RE: DA Advice for MCU14/0079.02, Meta St Mooloolaba

Following is urban design and architectural advice on the 'change to approval' application for the above project. This specialist advice has been prepared to assist Council's officers in assessing proposed changes to the 10 storey unit development initially approved in 2014.

Meta St DA Review DA0014/0079.02
 Assessment for Sunshine Coast Council

Urban Design
UD 02 A

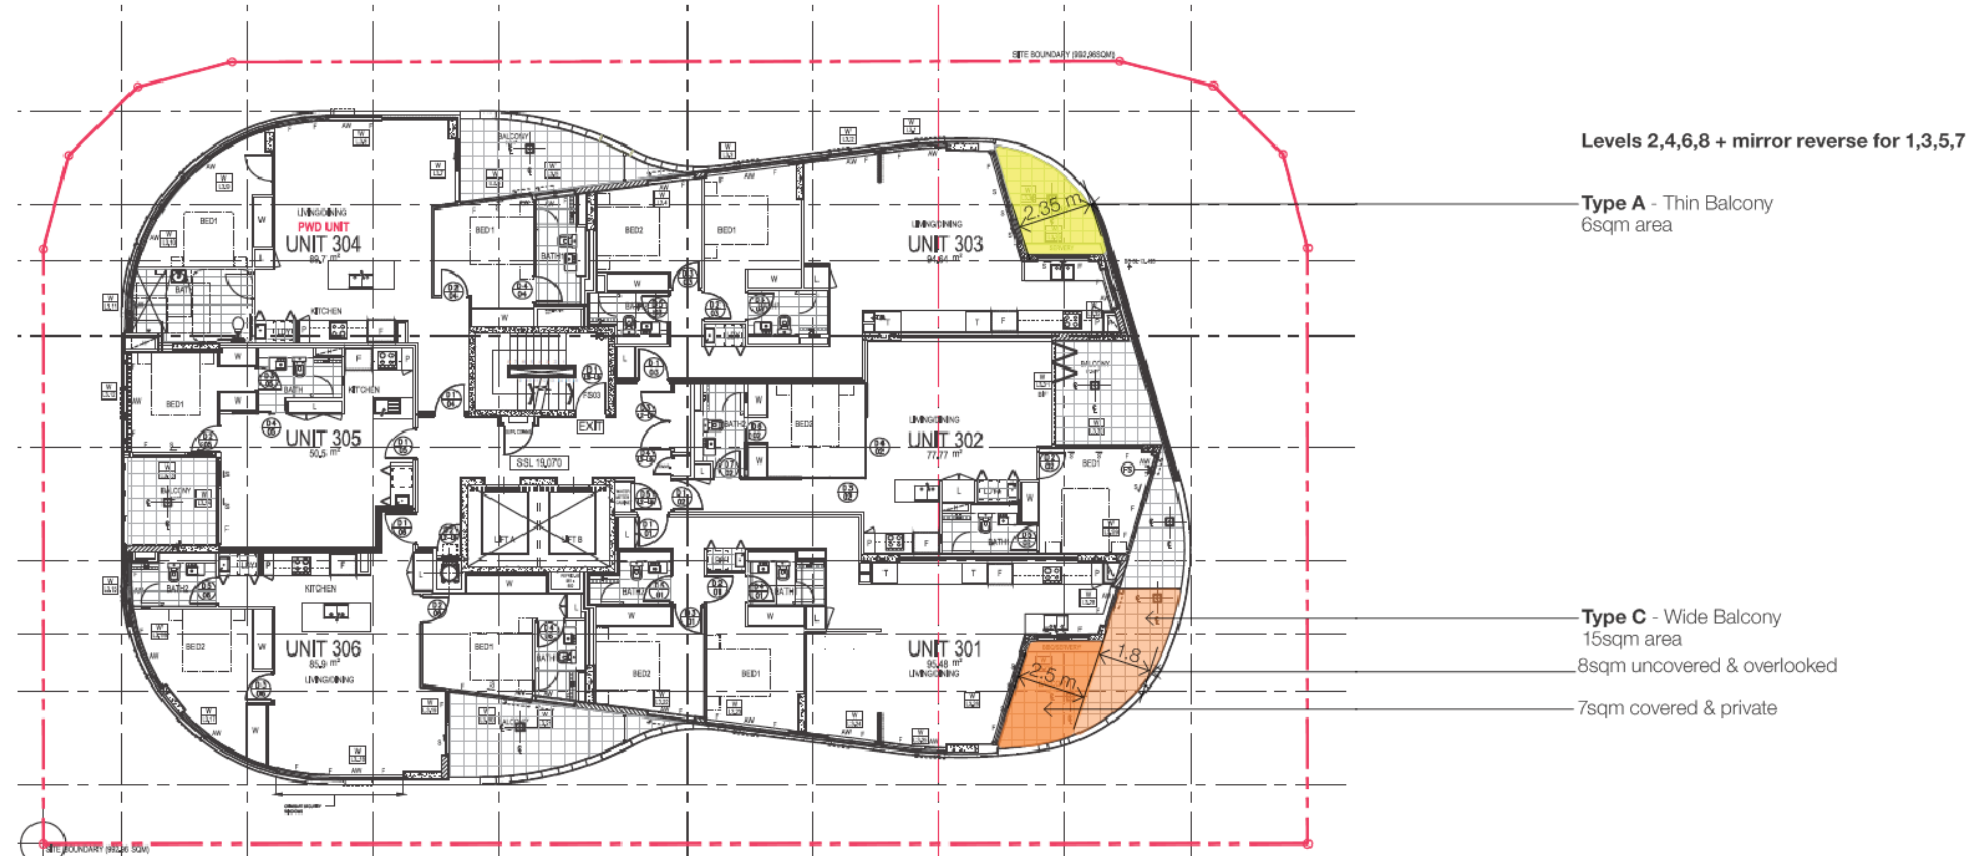
1. The change in location of the perforated screening from levels 2, 4, 6 & 8 to intermediate levels sees a reduction in the diagonal 'ripple effect' from floor level to floor level. The result is more of a bland series of horizontal waves > a subtle but inconsistent change from the approval (refer Drawing UD 02);
2. The replacement of sloping concrete balustrading on all corners to a perforated metal screen with a vertical junction impacts on the organic flow of the outer edge of the balconies > a subtle but important part of the design (refer UD02);
3. The use of fine grain perforations instead of the larger holes strips the building

- of its visual interest and playfulness. The finer perforation s are still see-through which diminishes privacy for residents (refer Drawing UD 02);
4. The deletion of the concrete lip/up stand across the front of all balconies reduces the thickness of the horizontal line sweeping around the building on each floor level, again reducing the impact of the architectural idea
 5. The increase in glass balustrading further reduces sweeping horizontal lines of the building and also reduces the amount of privacy to the deck Types A & B on levels 2, 4, 6 & 8. There is also a decrease in privacy to on deck Type A on levels 1, 3, 5, 7 & 9 (north east corner). (refer Drawing UD 02);

Perforated metal screen with angled join to concrete balustrade

NOTE: Vertical join in materials not part of original approval

Positioning of perforated balustrading creates a diagonal wave pattern up the buildings front elevation

Vertical join in materials not consistent with approval

Proposed positioning of perforated balustrading creates a less dynamic series of horizontal waves

Levels 2, 4, 6, 8 have less solid balustrading and privacy

1. Reinstatement of the screen balustrading to achieve the diagonal ripple effect;
2. The use of a larger perforated metal balustrade to deliver the original 'playfulness' of the building and increase privacy to the balconies;
3. While it is unrealistic to expect the extent of concrete balcony to be increased, Council should ensure that any joins between metal and concrete balustrading are consistent with the curved join in the approved design;

Urban Design
 UD 04 A

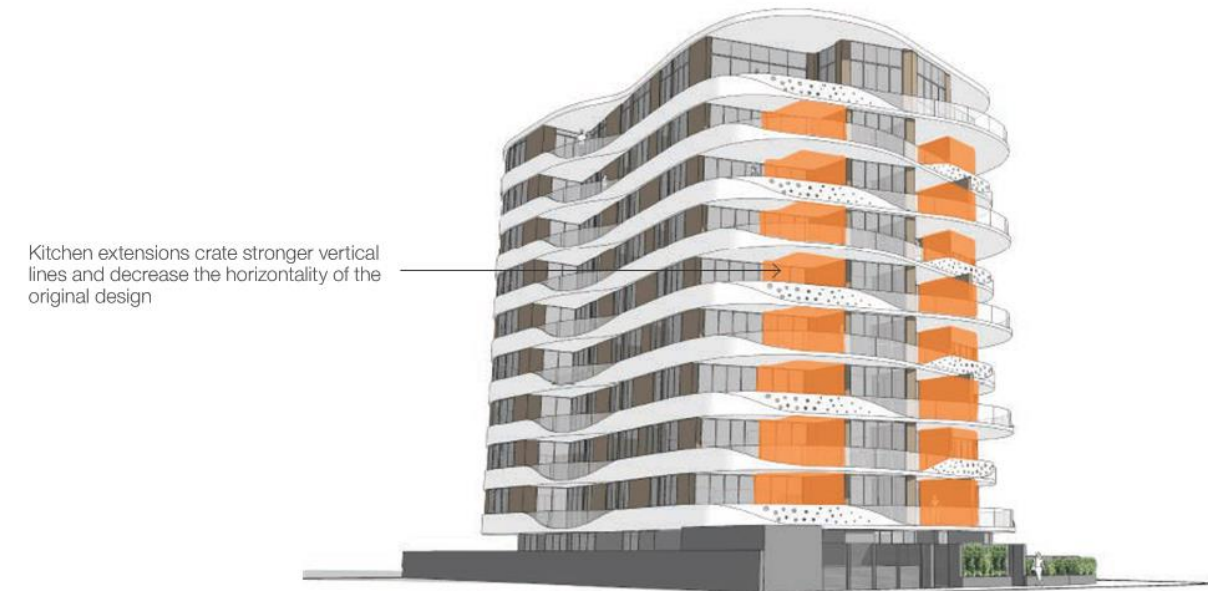
6. The applicant proposes to extend the kitchens on units 1 and 3 on each floor level out by approximately 2.8m onto the Type A and 2.4m onto the Type C balconies. This reduces the useable open space on these balconies to approximately 6sqm and 15sqm respectively. In balcony Type C, given this is overlooked from above, the effective useable open space is also reduced to 7sqm. (refer Drawing UD 03);
7. The kitchen extension limits the opportunity for non-mechanical, screened clothes drying area as per condition 12 of the Approval.
8. The kitchen extensions also impact on the built form by interrupting the effect of the horizontal glazing and reducing the horizontality of the architecture. (refer Drawing UD 02);

The kitchen extensions are inconsistent with the approval. The outcome for balcony Type A is in conflict with PO11 of the Multi Unit Res Code which stipulates "a balcony or similar private open space area directly accessible from the main living area which is not less than 12sqm in area with a minimum dimension of 3.0m".

The impact of the kitchen extensions on Balcony Type C is not consistent with the *Purpose and Overall Outcomes* of the Multi-unit Res Code as it delivers a useable balcony area of only 6sqm as the rest can be overlooked and is unshaded.

Approved Plans 2014 - Impact of prosed kitchen extensions

Approved Plans 2014 - Proposed without Type A kitchen extensions

1. Request of the applicants demonstrate condition/code compliant solutions for clothes drying and all balconies; and
2. Request the applicant model kitchen extension options for Type A and C Balconies that are more consistent with Type B as a minimum sized balcony; and
3. Request the applicant model kitchen extension materials and colours for Type A and C that that reinforce the horizontal banding intended in the original approval;

4. Consider not approving kitchen extensions on Type A balconies; and
5. Condition colour and materials to kitchen extension on Balcony Type C that reinforce the horizontal banding intended in the original approval
